## Brisbane Central Business District Bicycle User Group

This letter is to convey the views of the CBD BUG in relation to the Development Application A004162925 of the Howard Smith Wharfs. As in line with other CBD BUG submissions this submission is in regard with how this development will impact on people cycling to, from or through the site to be developed.

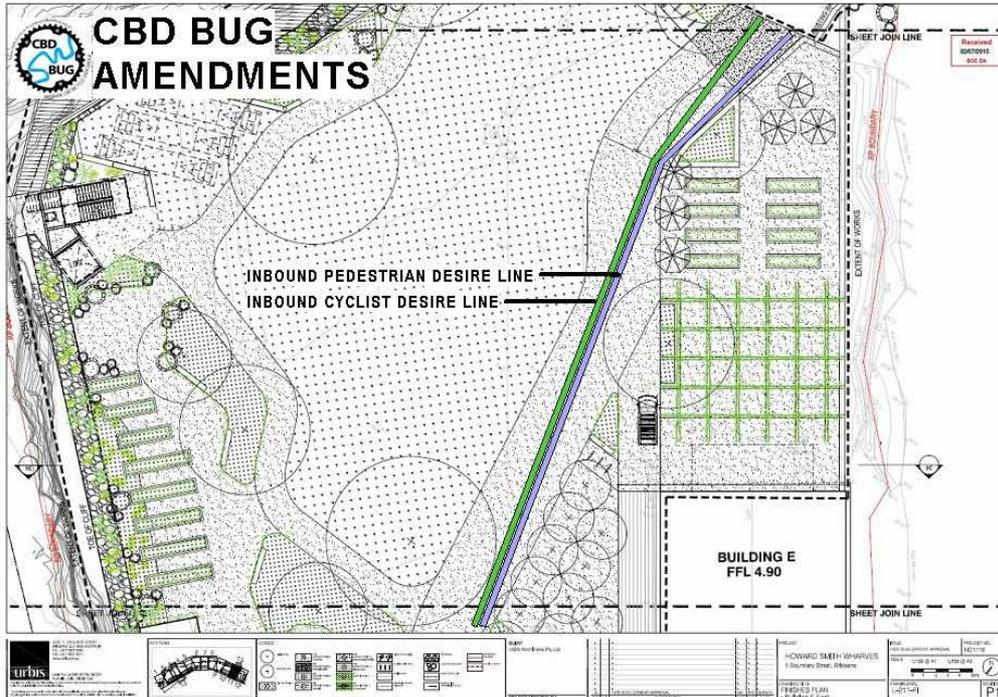
The CBD BUG is disappointed with the proposed alignment of the primary cycling corridor through the site. The number of curvatures has been increased from current 3 to approximately 11 with all additional 7 being unnecessary. It has been noted they have been made excessively tight. The CBD BUG does not view this as a suitable outcome for a path that forms part of SEQ Principal Cycle Network. Unnecessary path curvatures and tight curvature decrease the amenity, safety and capacity of cycling corridor though limiting one cyclist's ability to overtake another cyclist's. Due the very nature of cyclist having to lean into a bend (to counter act centripetal force) the effective path capacity is reduced at bends as is the effective width. Such designs would not be built into a primary general road corridor and neither should they be built into a primary cycling corridor. Please see attached amended plan L-211-F1 which clearly shows unnecessary curvature that can be removed providing a gently sweeping curve which provides excellent lines of sight that does not impede one cyclist's ability to overtake another.
